**Item 5.****Development Application: 524 Bourke Street Surry Hills**

File No.: D/2017/1749

**Proposal Summary:** Permission is sought for alterations and additions to a heritage listed terrace house, including ground and first floor rear extensions, a rear roof extension, a swimming pool and construction of a new garage facing Olivia Lane with a studio above and a new excavated basement/cellar in the rear yard and under the garage.

Figure 5: Basement level

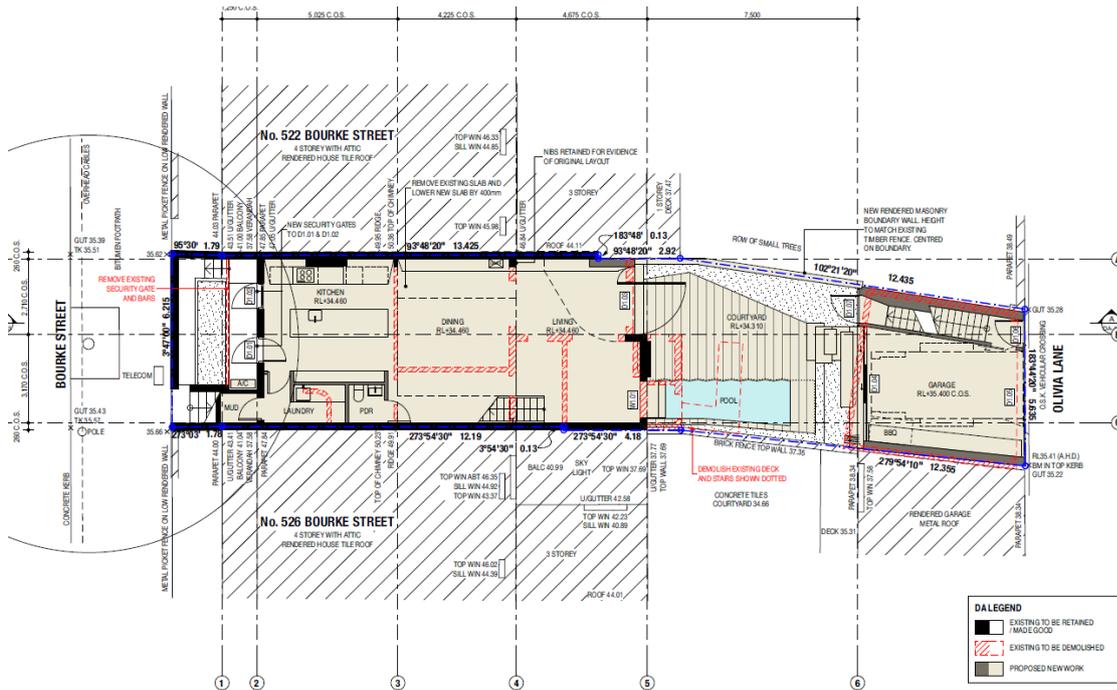
43. However, a concern is raised that the extent of the basement precludes the provision of deep soil planting as required under Section 4.1.3.4 of the Sydney DCP 2012 and will be difficult to construct without adverse impact on neighbouring properties.

45. A further concern is raised that the depth of excavation adjoining the side boundaries will adversely impact the structural integrity of the boundary conditions and neighbouring properties. To address this concern, a condition is recommended requiring the extent of the basement to be confined to the footprint of the garage, with the basement component setback from the side boundaries by 500mm.

- (a) Reduce the extent of the basement such that it is confined to the footprint of the garage and excavation is setback 500mm from the side boundaries.

Figure 20: Section with 9 metre height standard in blue

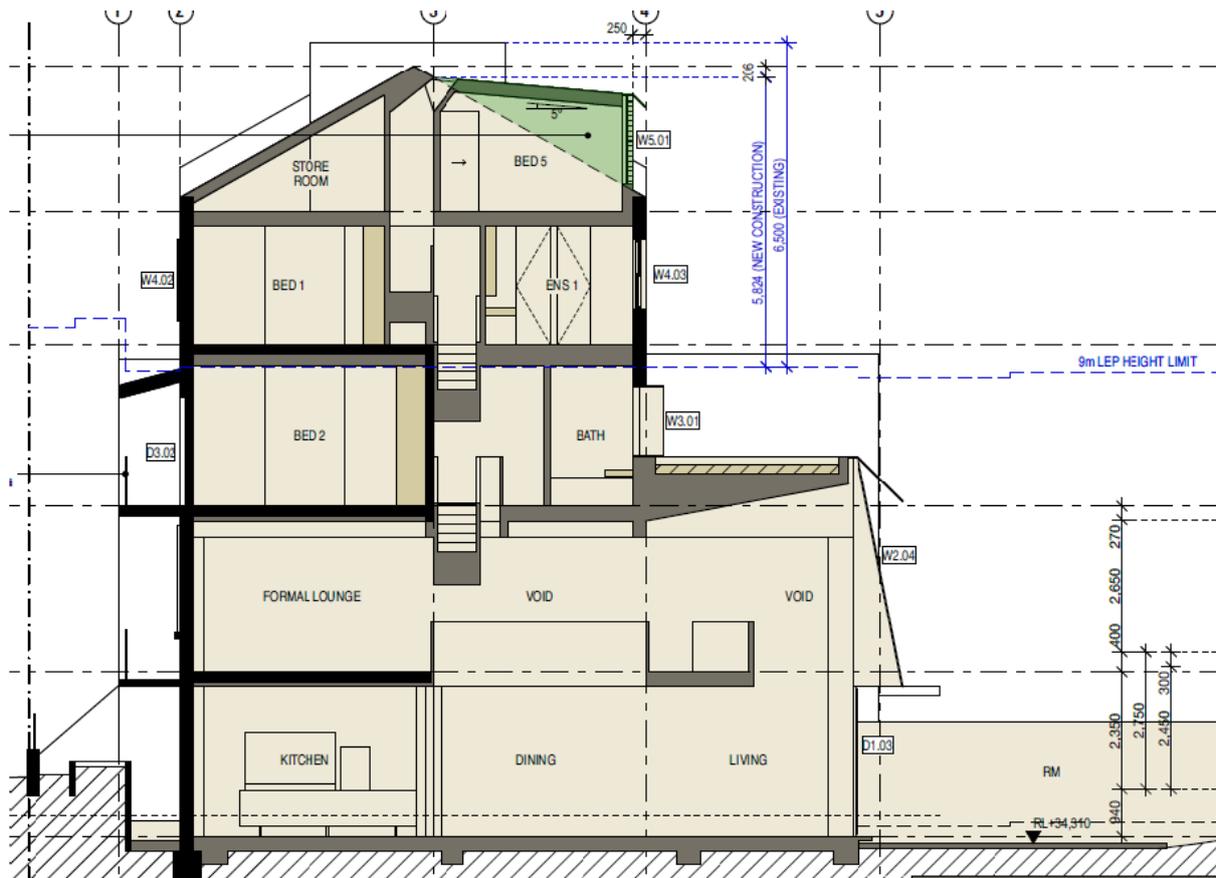
23. The applicant has submitted a request to vary the maximum nine metre building height pursuant to Clause 4.6 of the Sydney Local Environmental Plan 2012. The rear roof extension exceeds the maximum height standard under Clause 4.3 by 5.824 metres or 65%.

- (c) to promote the sharing of views
29. The works above the height standard are consistent with those previously approved under D/2010/2111 as amended and generally consistent with Council's controls for rear roof extensions to terrace dwellings. While the planning controls at the time the previous application were originally assessed were different, the principle and design guidelines for rear roof extensions to terrace houses are essentially the same. Furthermore the works will not adversely overshadow and reduce privacy to neighbours. Compliance with the numerical standard is therefore both unreasonable and unnecessary in these circumstances. Sufficient environmental planning grounds exist for the variation as the building already exceeds the height standard, and the proposed works will not substantially alter the built form and heritage significance of the item and conservation area.

32. The variation to the standard is consistent with the provisions of Clause 4.6(4) of the Sydney LEP 2012 and is therefore in the public interest. The variation to the standard is recommended for approval.
